# FINAL DRAINAGE REPORT

## MEADOWBROOK TOWNHOMES DIRT BORROW SITE EL PASO COUNTY, COLORADO

Project #43-089  
PCD Project No.CDR-18-009

DRAWN BY: SM CHECKED BY: JD SHEET 2 OF 3 **GR2**

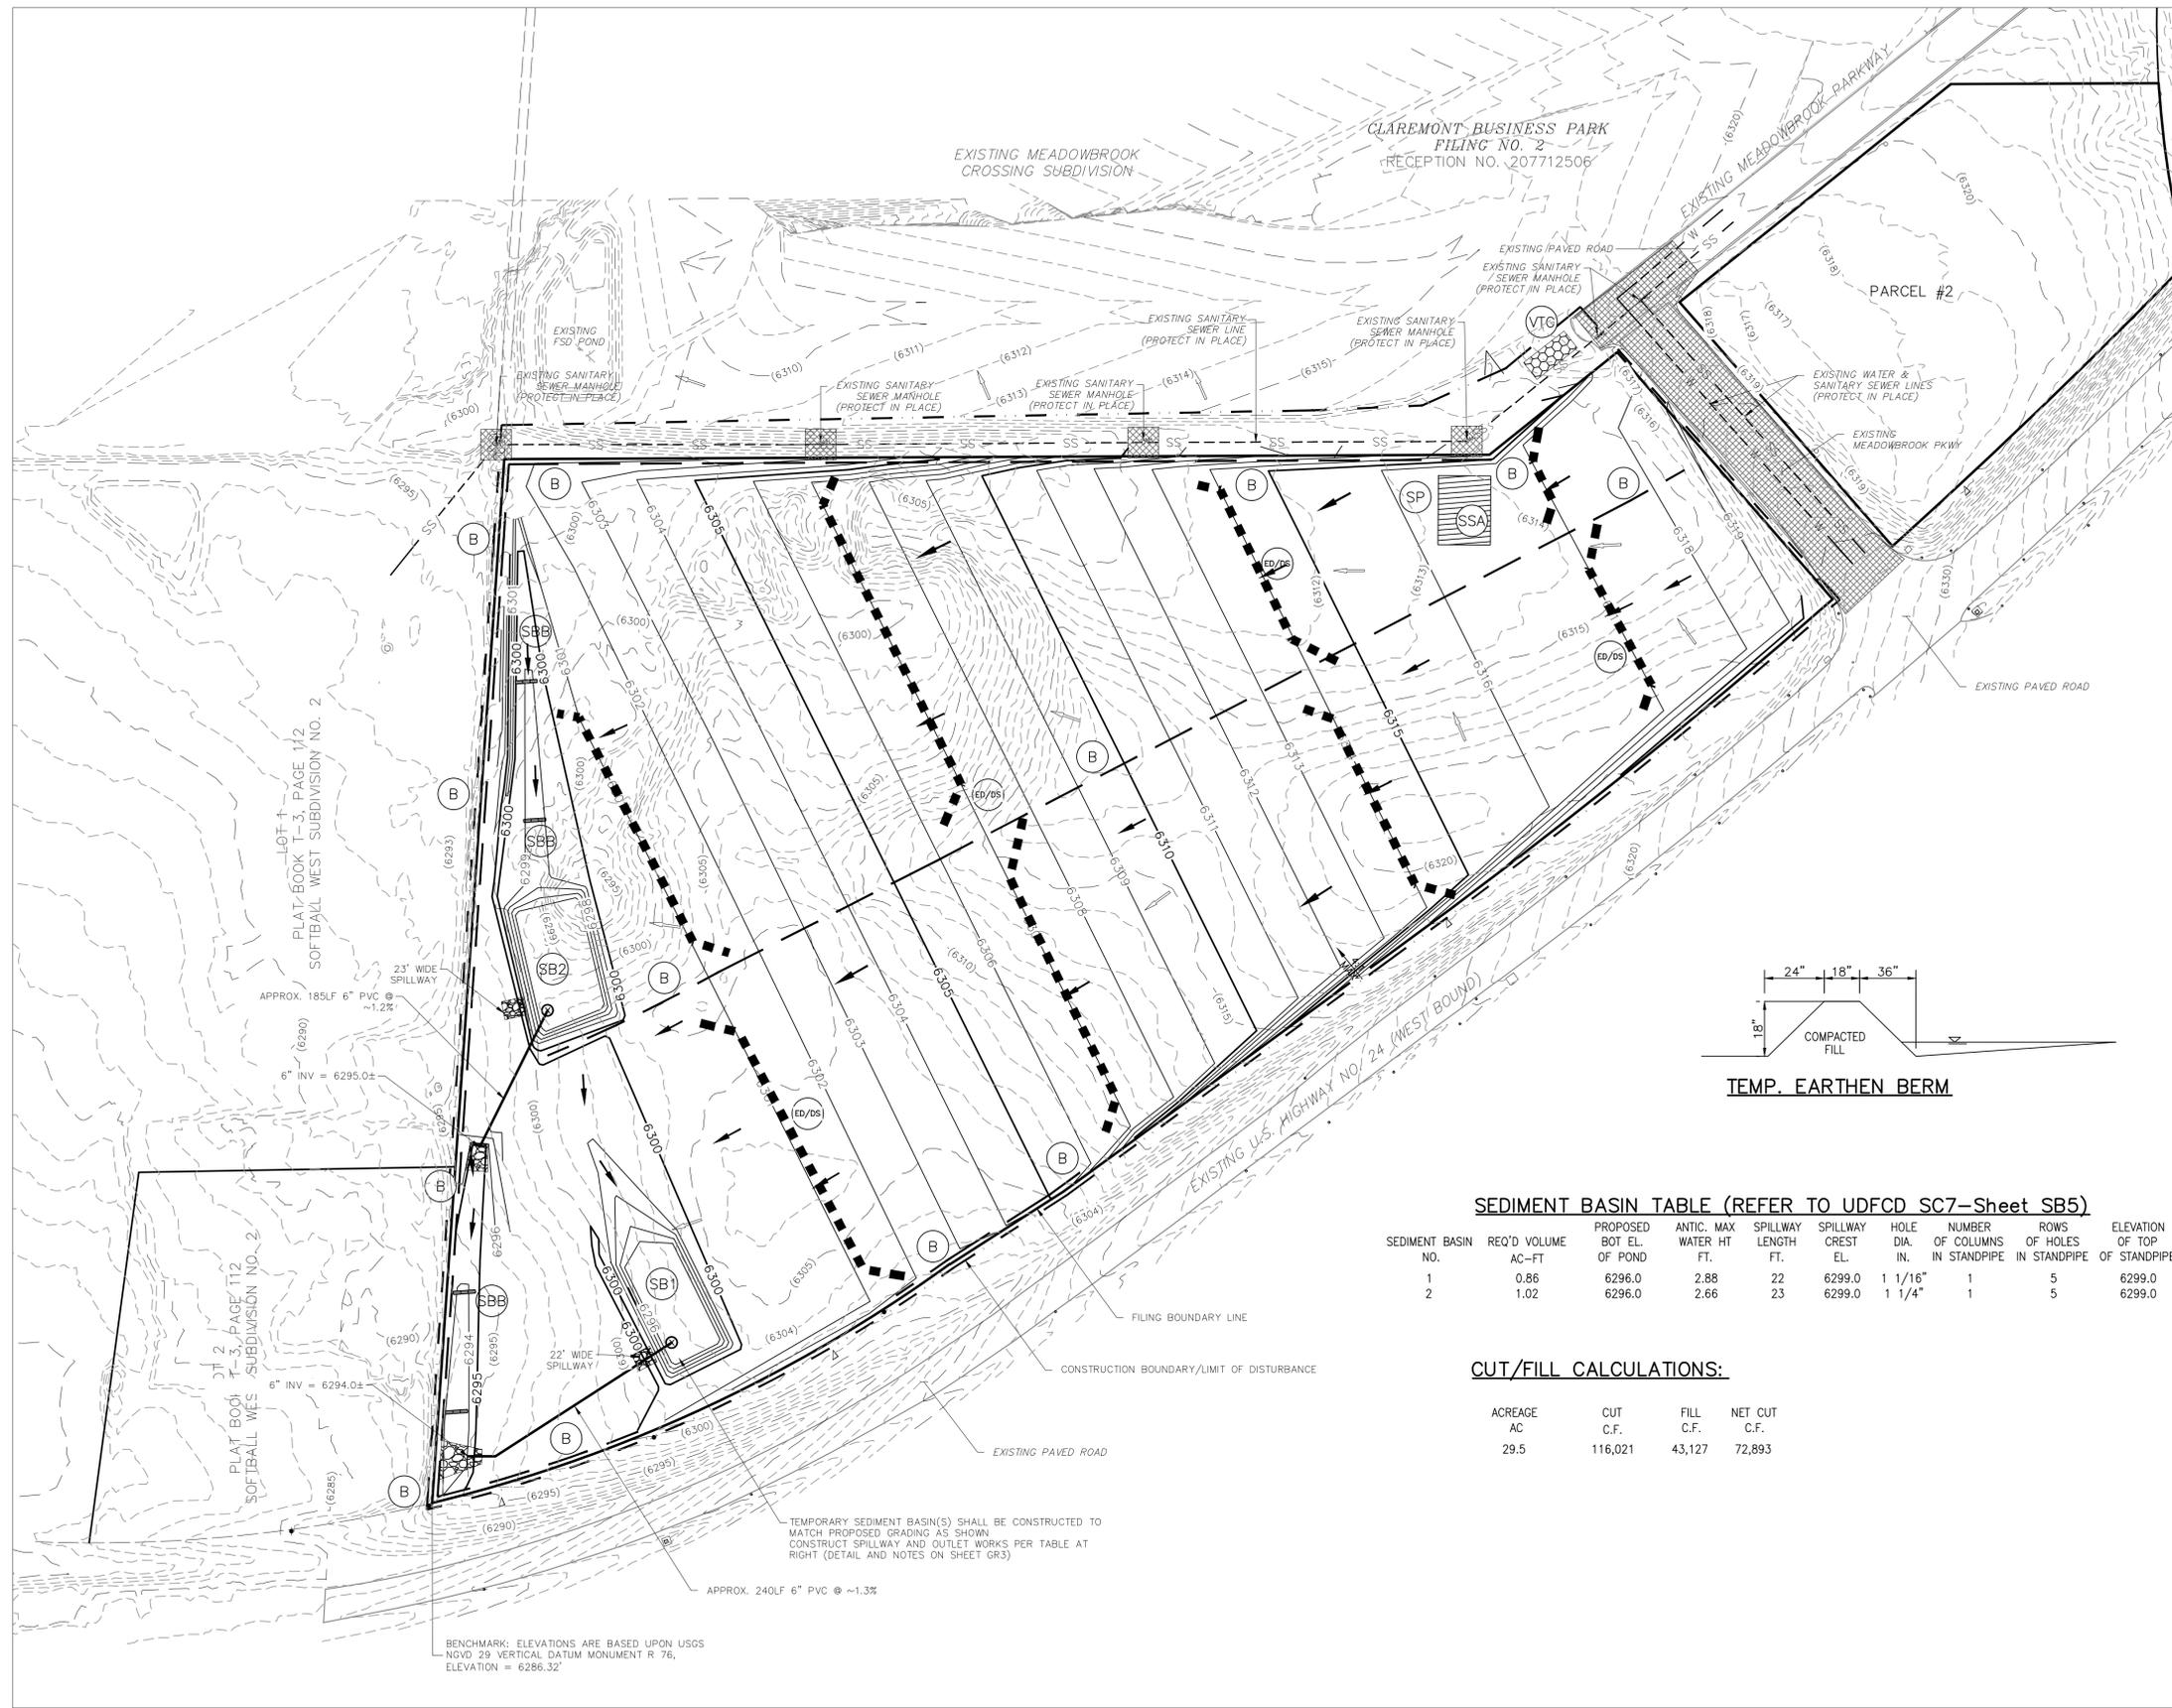
SB1 calculations and table on GEC indicates 22 ft. Revise.

SB2 calculations and table on GEC indicates 23 ft. Revise.
